**Development and Management Plan Update No. 1
Underground Utility Design and Water Balance Revisions
PSEG Power Connecticut LLC
Bridgeport Harbor Station Unit 5 Combined Cycle Project
Petition No. 1218**

**Connecticut Siting Council
Development and Management Plan Update No. 1
Combined Cycle Generating Facility**

**Bridgeport Harbor Station Unit 5
Bridgeport, Connecticut**

Design Revisions

WATER SYSTEM
 PROCESS FLOW DIAGRAM
 SHT 1 OF 2
 FLOW DIAGRAM DESIGN PIPING
 VERSION NO. 644911-FD002-S001

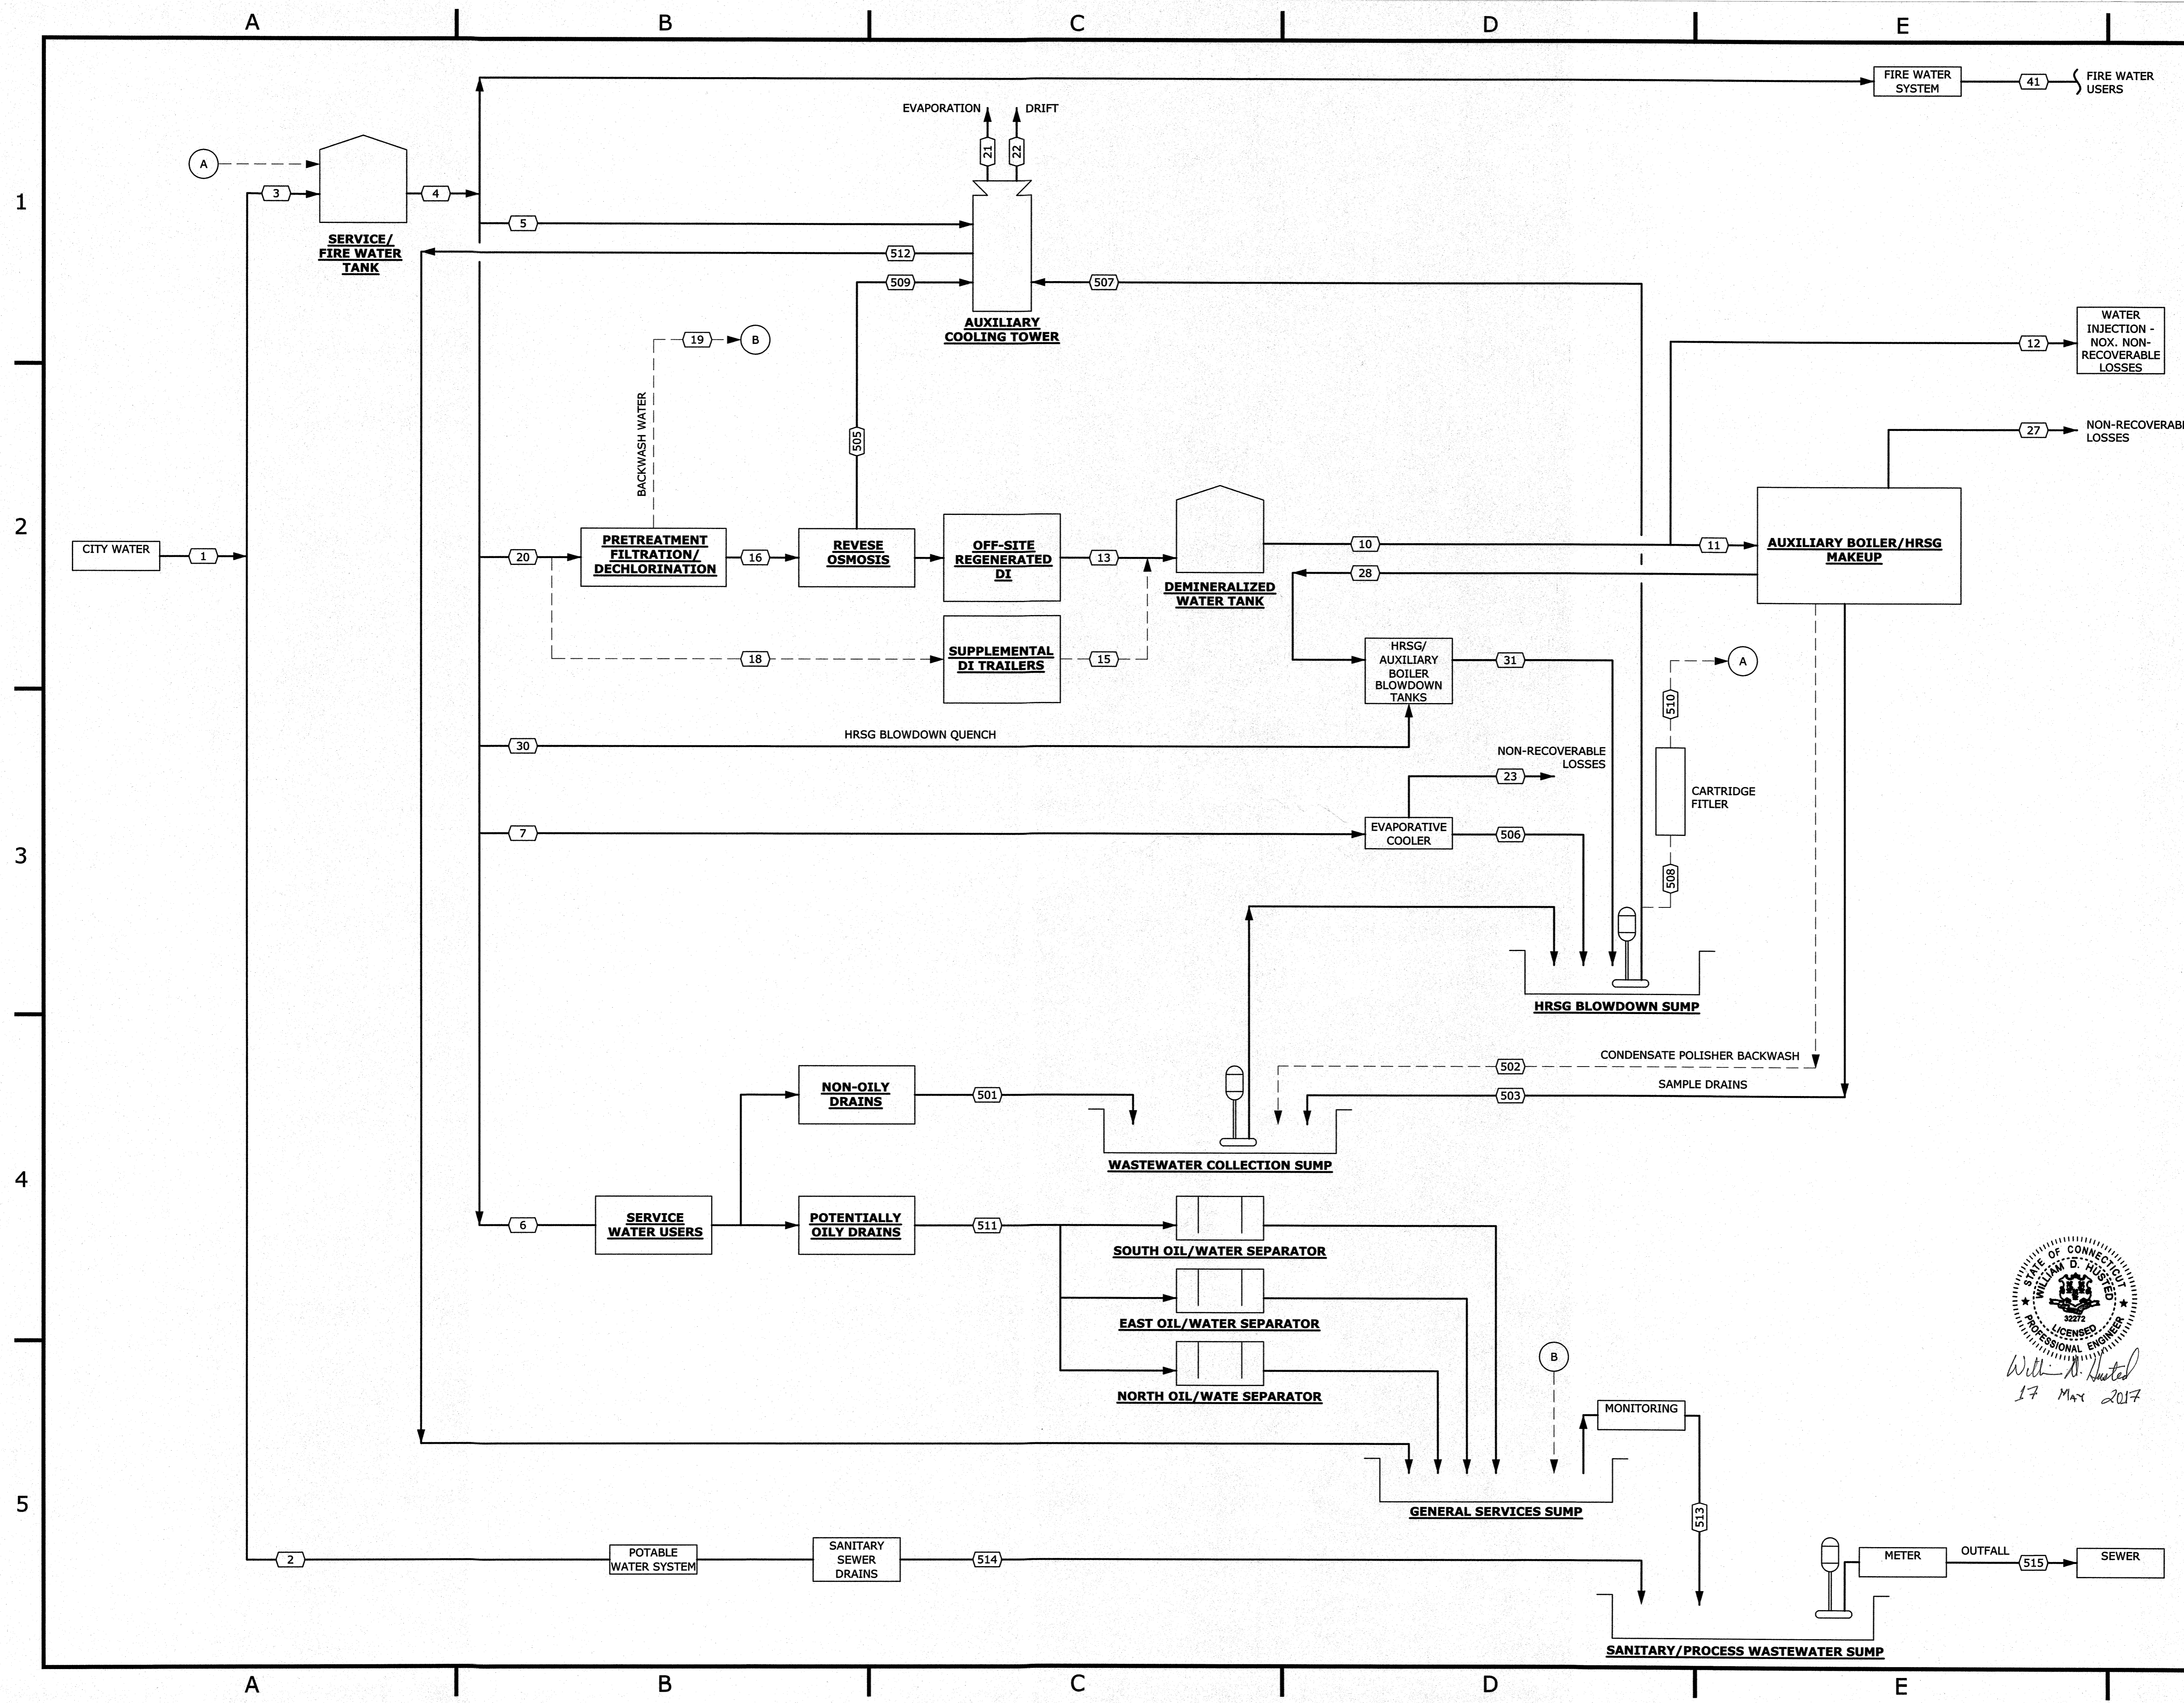
Similar to the changes in the underground design detailed above and in Exhibit 1, PSEG and SNCL have also conducted a review of the site water balance with the objective of reducing freshwater requirements and wastewater discharges, where possible, for the various plant operating scenarios. The revised water balance diagram and table of operating cases is included as Exhibit 2. The prior water balance was provided in D&MP Phase 2, Exhibit 4.

The proposed changes, while collectively not significant, more accurately represent the anticipated plant operating scenarios. The water balance includes flow path rerouting to accommodate the following:

1. Removing the discharge from the oil water separators (OWS) to the cooling tower;
2. Eliminating the discharge of minor stormwater quantities from exterior containments to the City Water Pollution Control Authority (WPCA) collection system;
3. Improvements in the ability to reuse / reprocess water under certain conditions.

The water balance diagram has been optimized during final design to provide additional operational flexibility, reduce cooling tower and circulating water system fouling potential, and incorporate seasonal variations in cooling tower evaporation rates. The optimized water balance results in a minor reduction in average annual facility water supply requirements and maintains process wastewater discharge flow and quality characteristics within allowable ranges for discharge to the sewer.
